UNSAFE & UNSUSTAINABLE

*Experts Review the Center for Sustainable Shale Development's
Performance Standards for Shale Gas Development*

Prepared for
the Delaware Riverkeeper Network

2014

Figure 1.

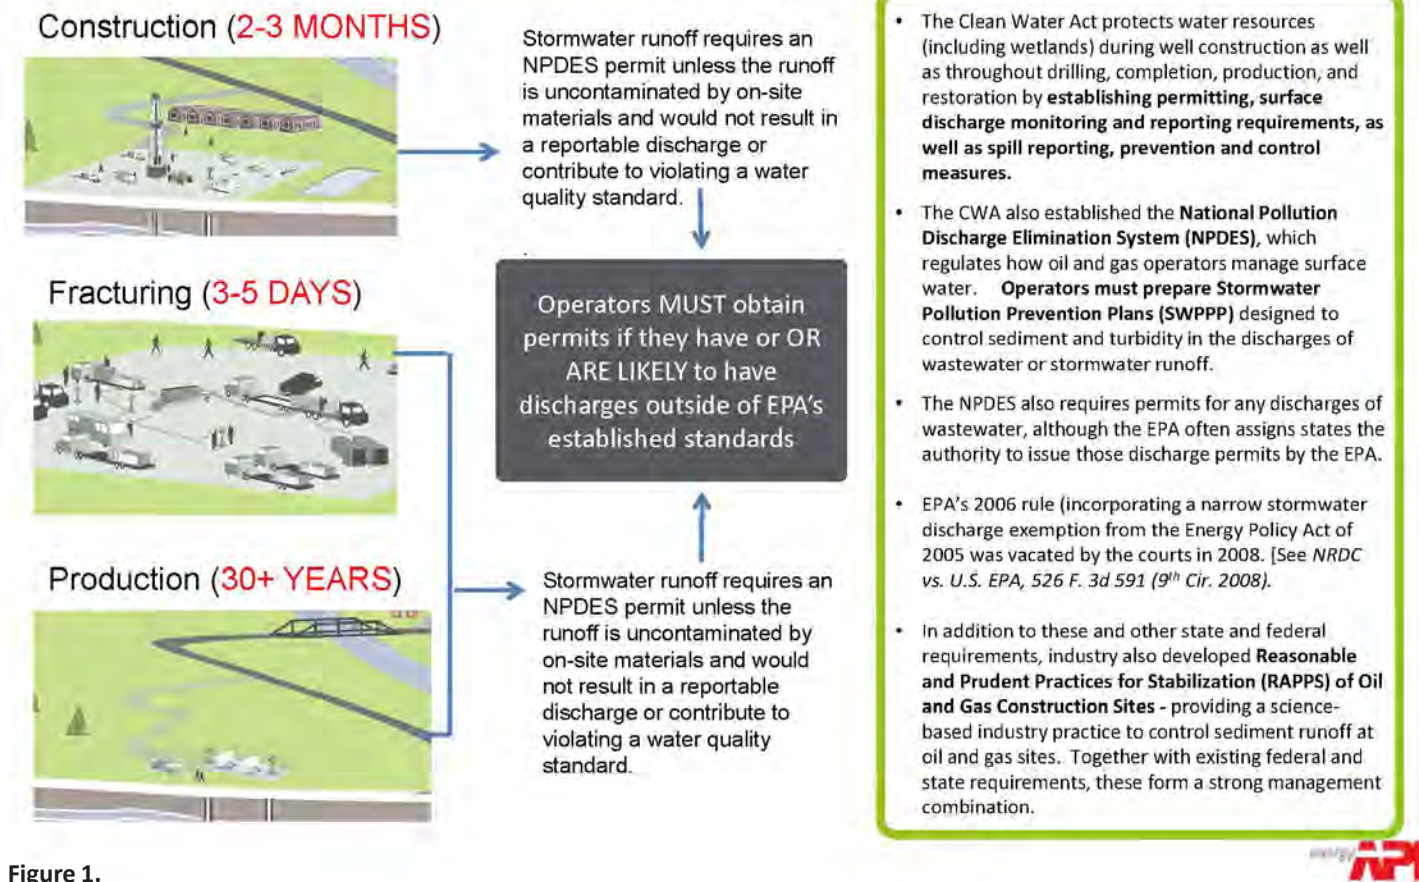
This misrepresentation is not uncommon in the unconventional gas industry. A commonly cited diagram on the Energy From Shale web page (Figure 1) implies to the uninformed viewer that stormwater from an unconventional gas well pad requires a stormwater NPDES permit under the Clean Water Act, but in fact this is only true if the stormwater comes into contact with fracking materials AND contributes to a water quality violation. Generally, stormwater NPDES permits are NOT required for unconventional gas well pads. Only flowback from the well is regulated by the NPDES program. This is very confusing to the public, and the industry diagram fosters this confusion. The Standards and proposed verification system are similar in nature regarding misleading implications.

Figure 1: Shallow and deep groundwater flow.

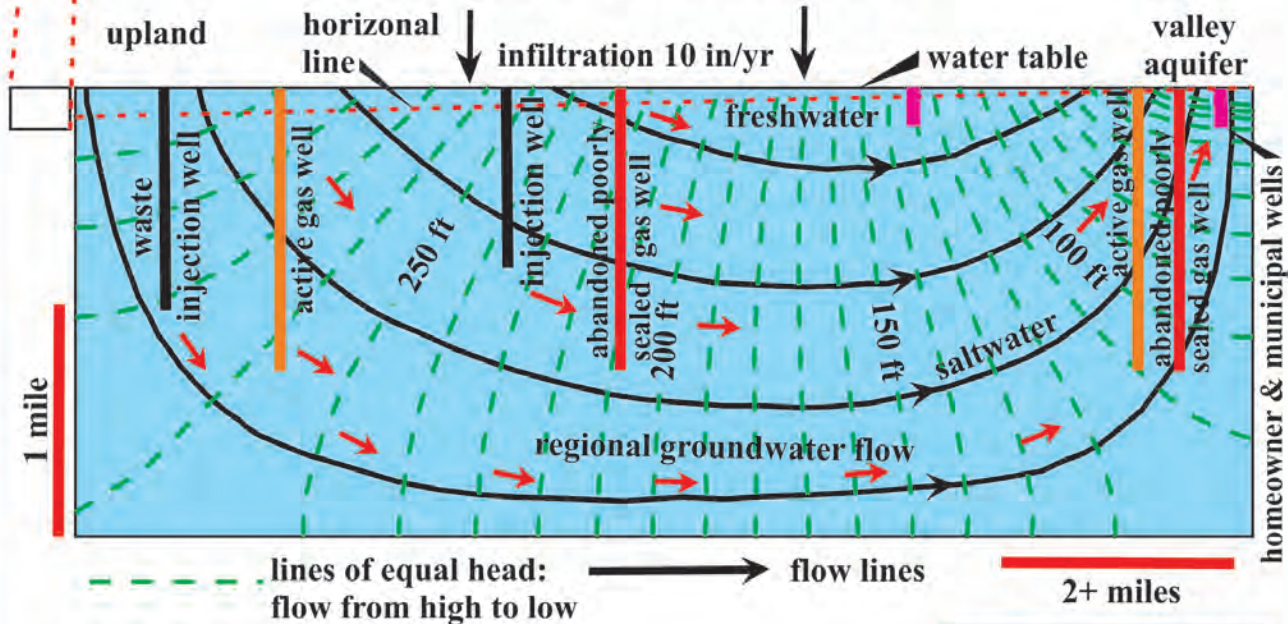
The operative AOR for this performance standard would need to extend far from each gas well array to regional base level river valleys where hydraulic fracturing fluids will eventually rise. Even then, this performance standard would not be able to stop the migration or subsequent contamination that would follow. Confining layers above production zones do

not stop the steady flow of groundwater to distant discharge locations. Thus, the underlying premise of this performance standard, as stated in the CSSD Performance Standards and in gas industry advertising, fails to account for dynamic, natural groundwater flow. Therefore, this performance standard is fundamentally flawed and cannot be achieved.

ation of deep and shallow groundwater flow vectors that may transport contaminants far from any on-site or near-site monitoring locations (see Figure 1; shallow and deep groundwater flow). As a result, this standard would prematurely relieve operators of responsibility for aquifer degradation, thereby leaving homeowners with unsafe water supplies in future years and no one to assume financial and replacement responsibility. Sealant failure may occur either slowly or catastrophically during high pressure hydraulic fracturing operations or during seismic events or ground motions imposed by adjacent well drilling operations. Once polluted with chemicals, the aquifer will be permanently degraded with no viable corrective action.

Figure 2: Regional groundwater flow.

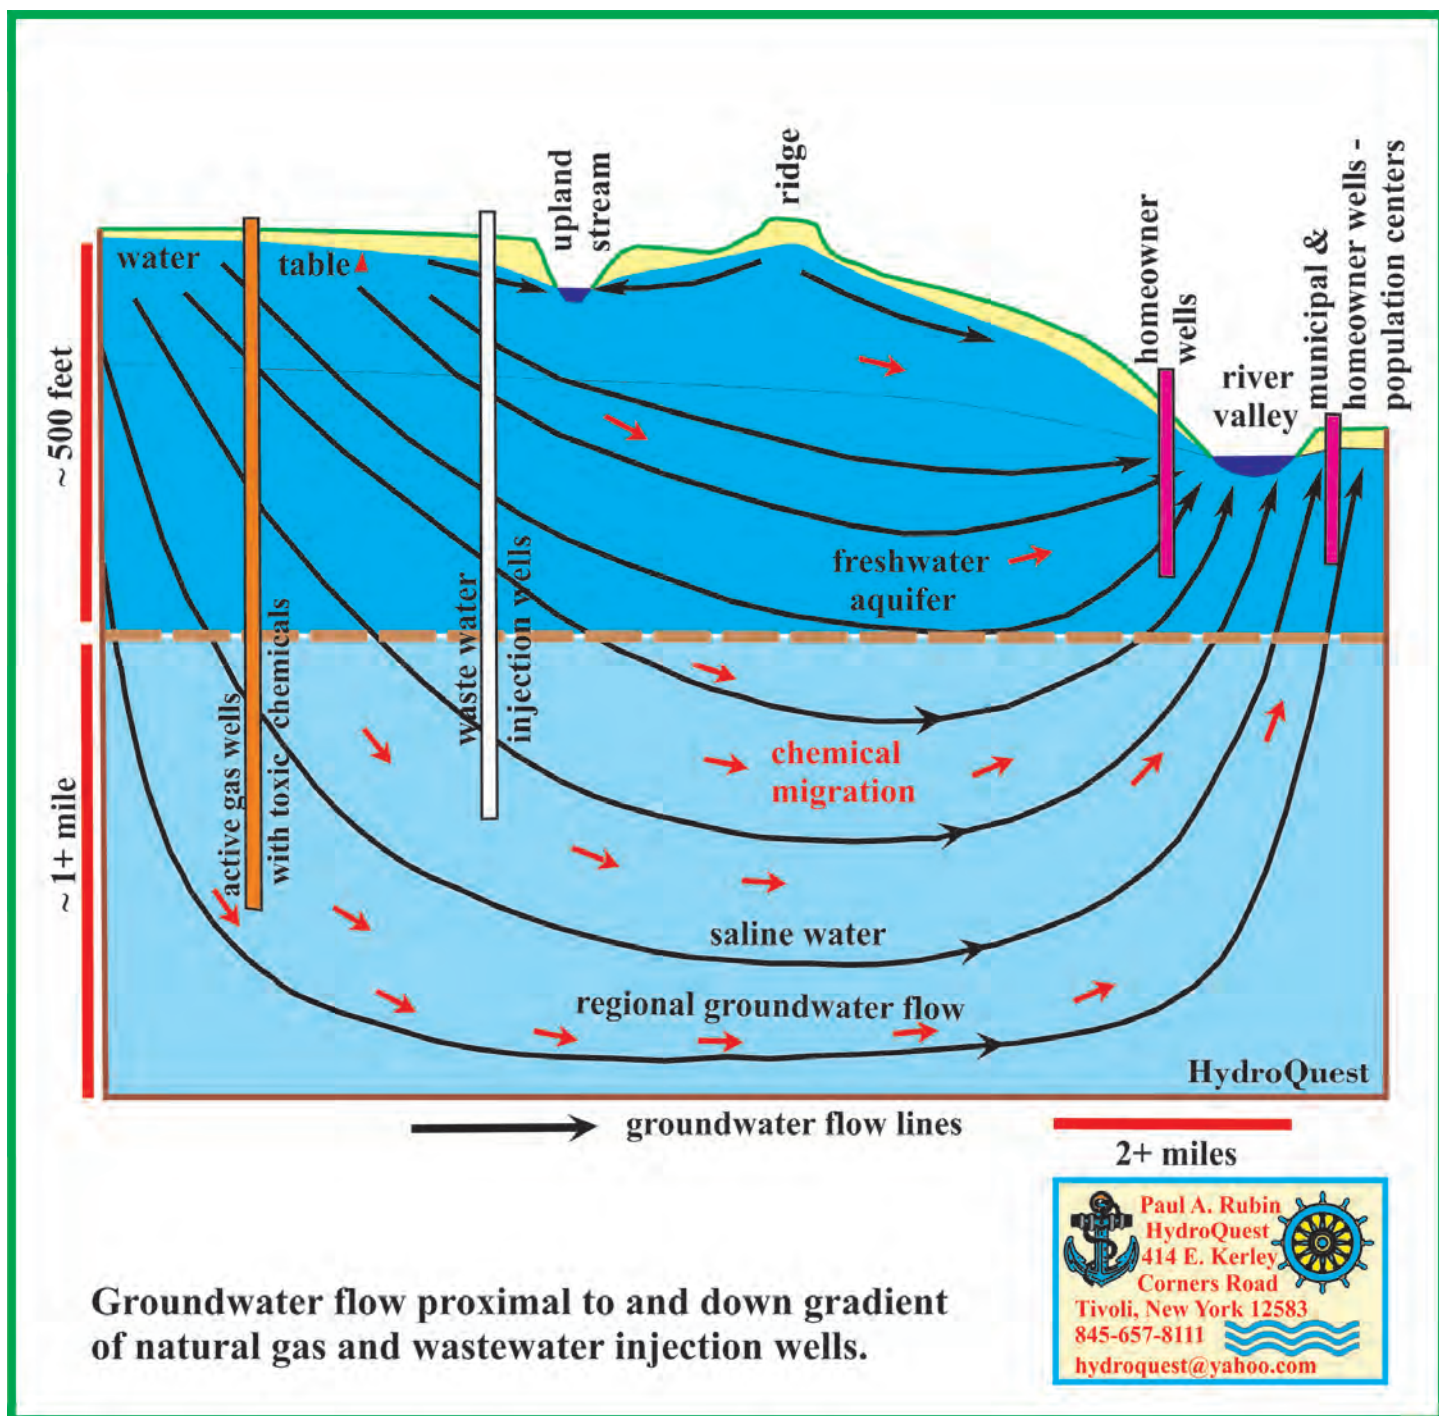
Therefore, hydrogeologically, the concept of finite Areas of Review as described in Performance Standard No 5 or setback distances that seek to “... *prevent adverse migration of hydraulic fracturing fluids* ...” (CSSD, p. 3) are flawed because groundwater moves. Additionally, groundwater flow rates or travel times (i.e., seepage velocity) vary markedly based on a number of factors which include hydraulic conductivity, hydraulic gradient, and effective porosity. Interconnected faults and fractures in anisotropic media can support flow rates orders of magnitude greater

Figure 3. The Deerpark Village, NY aquifer test documented fracture interconnectivity to a distance of at least 4,300 feet in the Appalachian Basin (Rubin5).

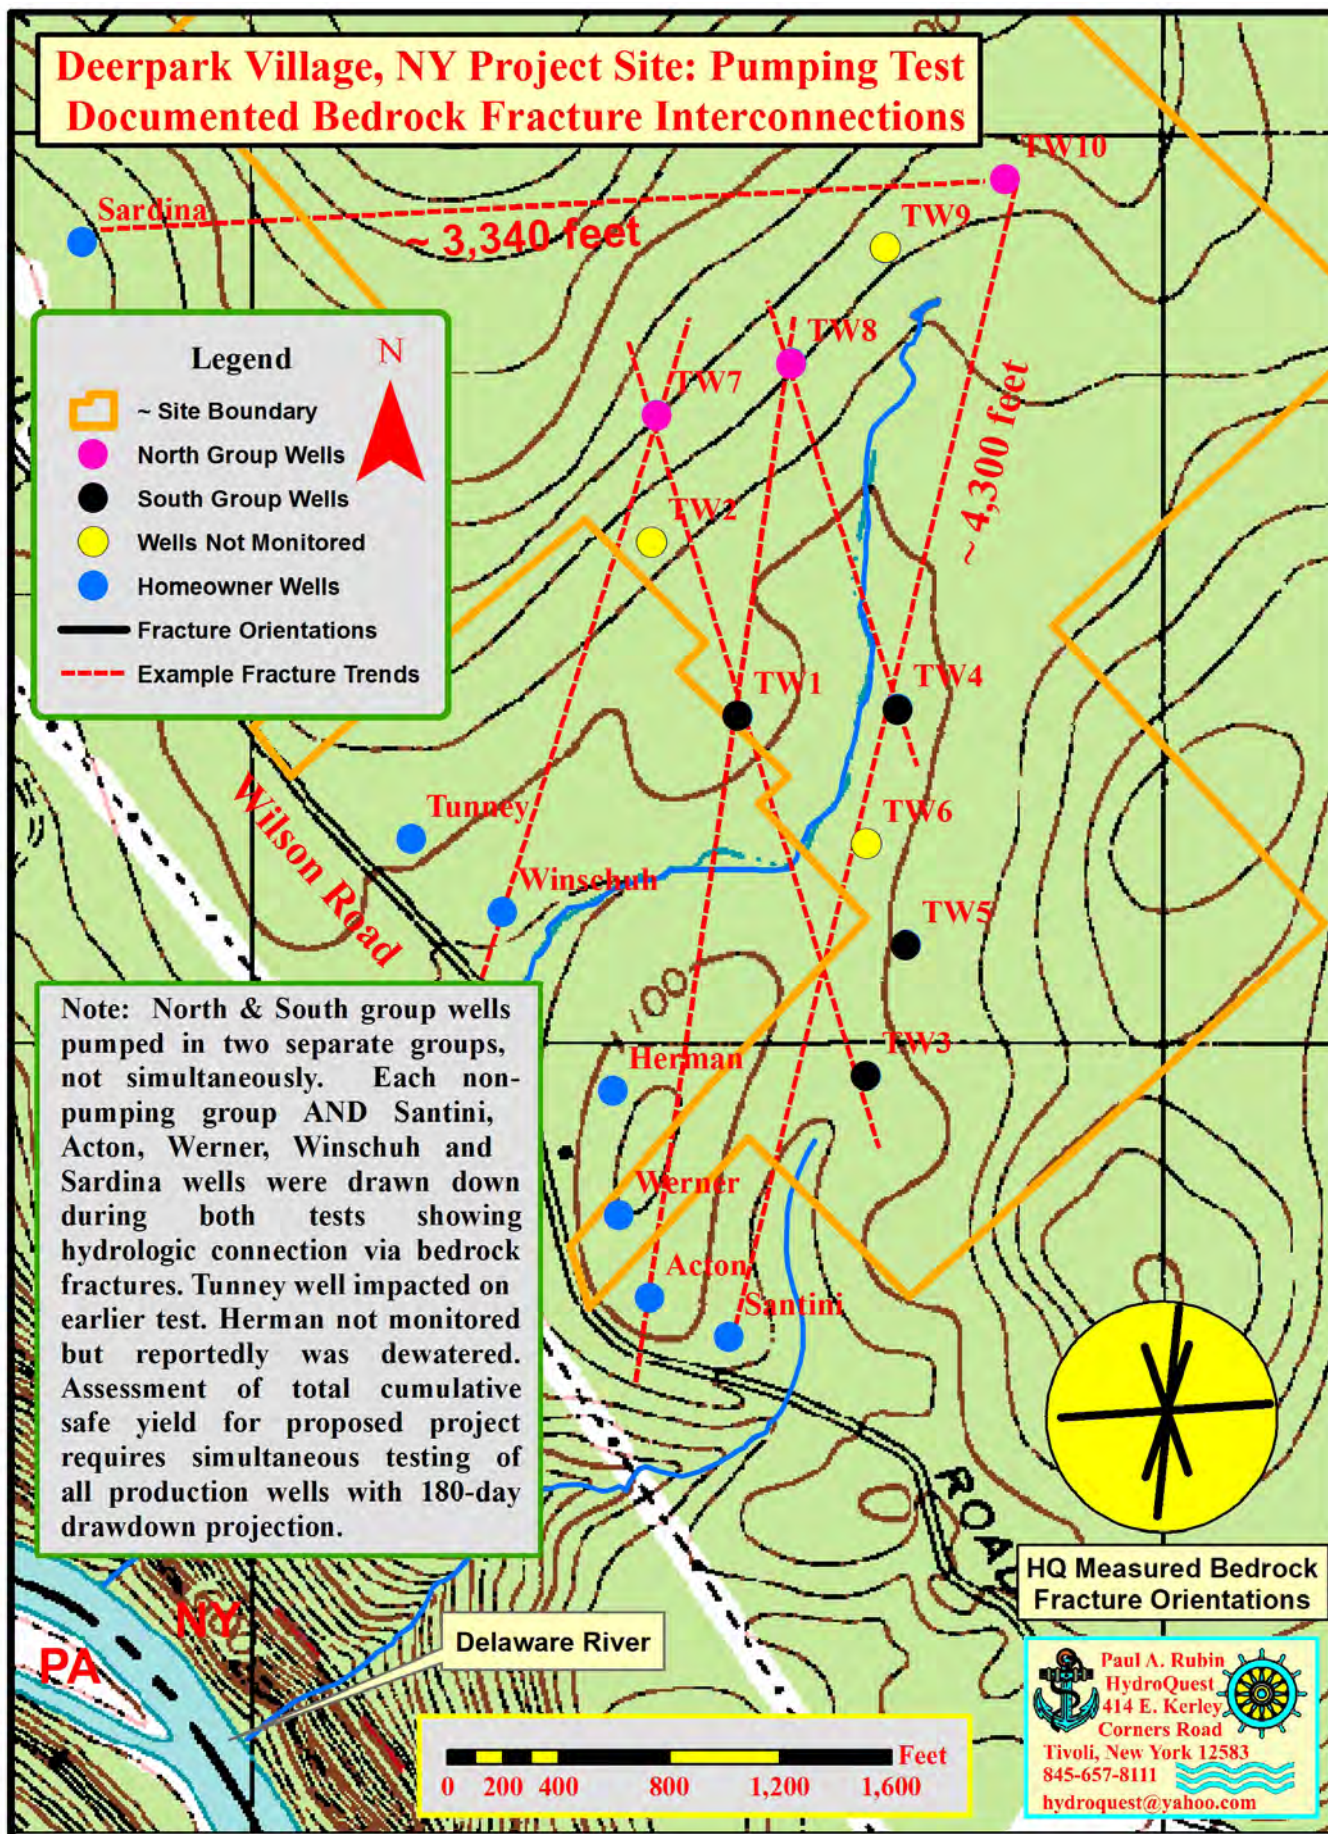
HydroQuest has reviewed two major aquifer tests within the Appalachian Basin (Rubin^{4,5}). The Deerpark Village aquifer test documented fracture interconnectivity to a distance of at least 4,300 feet (see Figure 3). Detailed, reproducible, hydrogeologic analyses represent the type of information required, but not provided, in the CSSD Performance Standard. Furthermore, this performance standard fails to take into consideration the increased risk of stray gas migration to homeowner wells situated proximal to fault zones. This Performance Standard fails to provide any empirical data or analyses of this nature that could be uniformly applied as a standard for establishing AORs, thus failing in its goal of sustainable shale development.

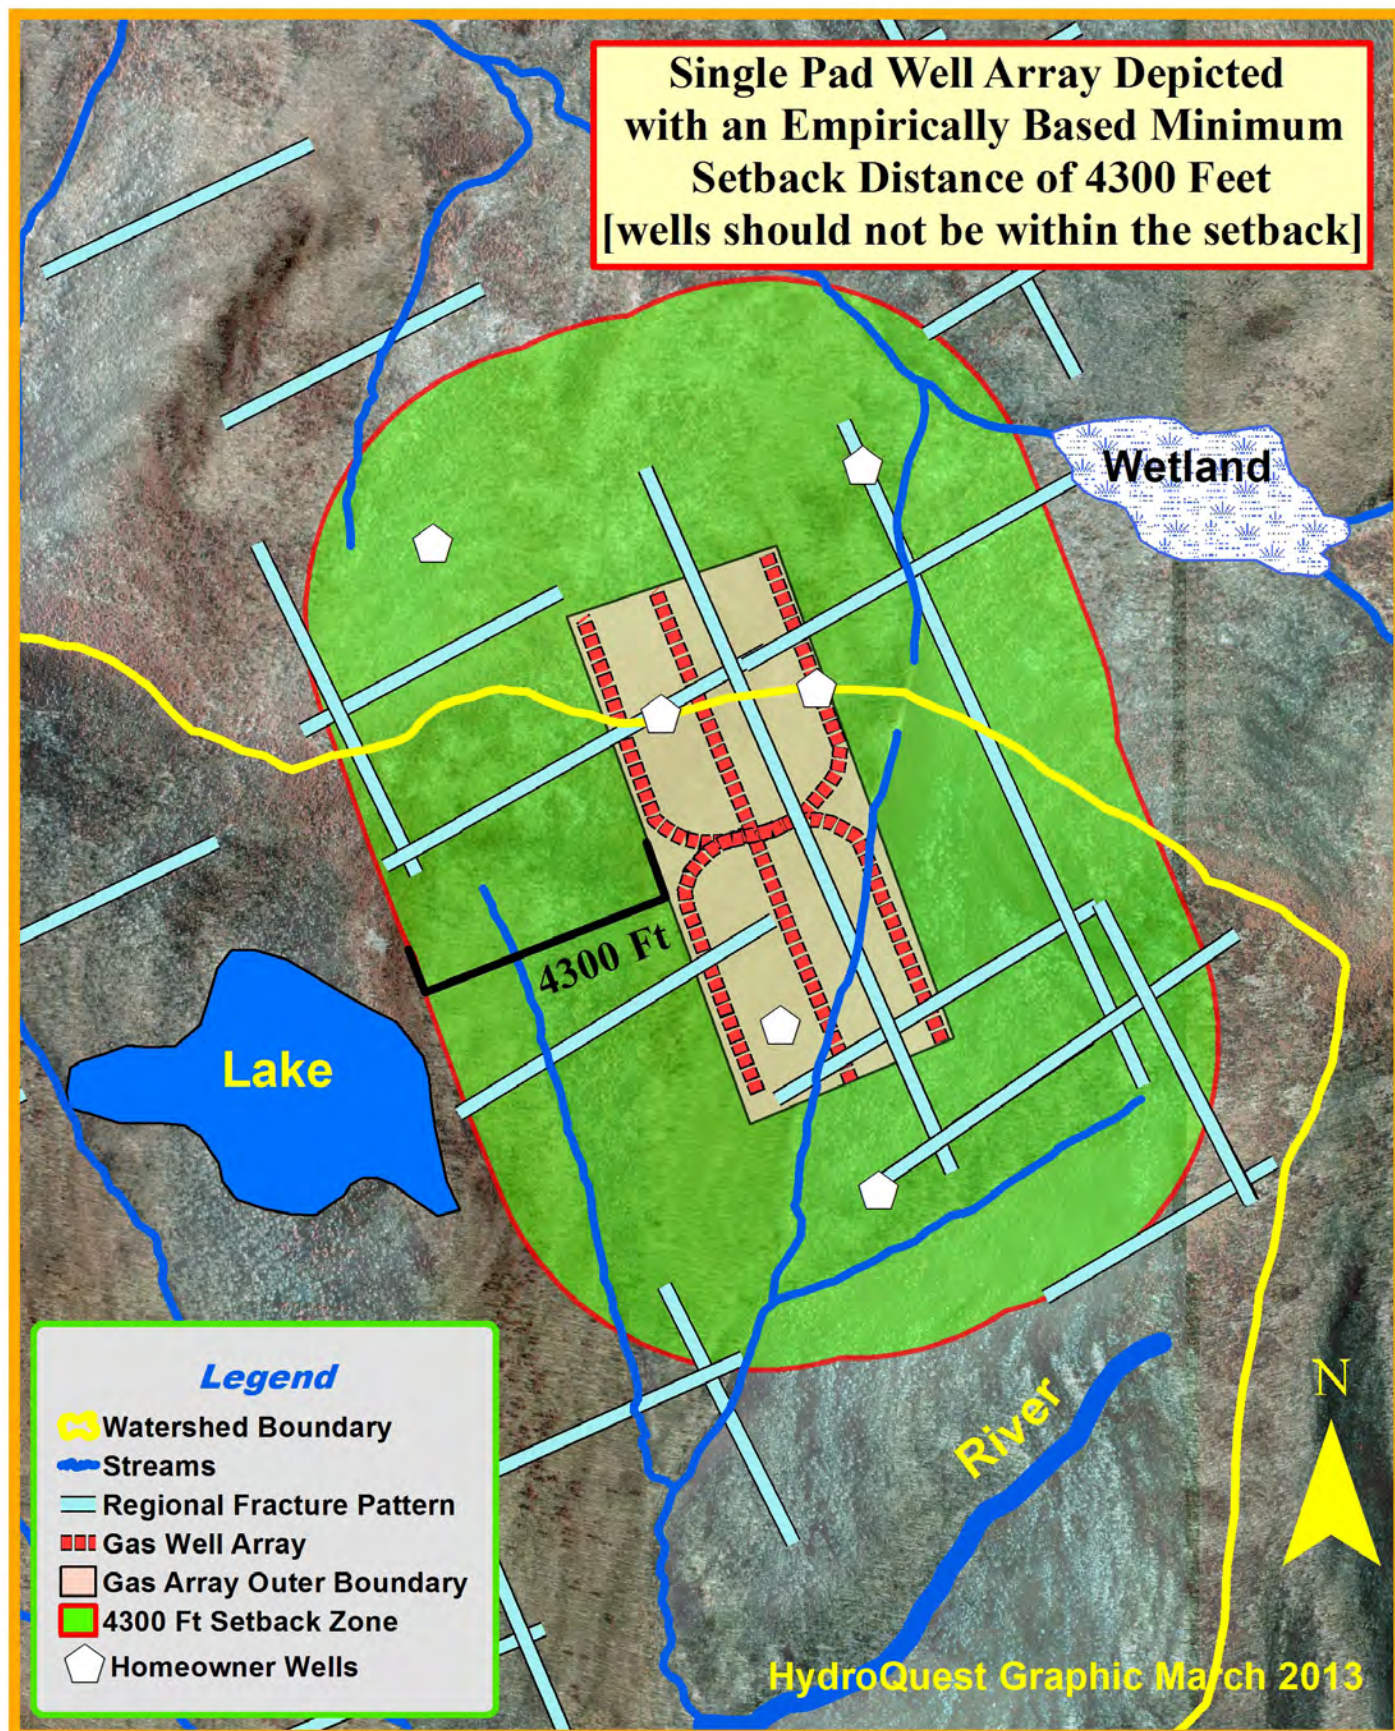
Performance Standard No. 6 (Paragraph 1) fails to provide justification and rationale for the baseline stated radial monitoring distance of 2,500 feet from wellheads that it sets. Numbers, such as the 2,500 foot radius stated in this performance standard, must be based on empirical, reproducible, data and analyses such as that used by HydroQuest in documenting areas of potential adverse impacts (see Figure 4).

Performance Standard No. 6 (Paragraph 1) fails to provide any scientific justification for specific standard monitoring or rationale for what is stated. There is no empirical data to support use of the 2,500 foot radius from wellheads, no stated chemical parameter list that would insure consistent uniformity between well sites, and no guidance relative to monitoring. Under this Performance Standard above, twenty different operators could easily arrive at a single well site with twenty different interpretations of the “standards.” There is nothing to provide operators with rigorous, empirically-based, standards to proceed consistently between well sites.
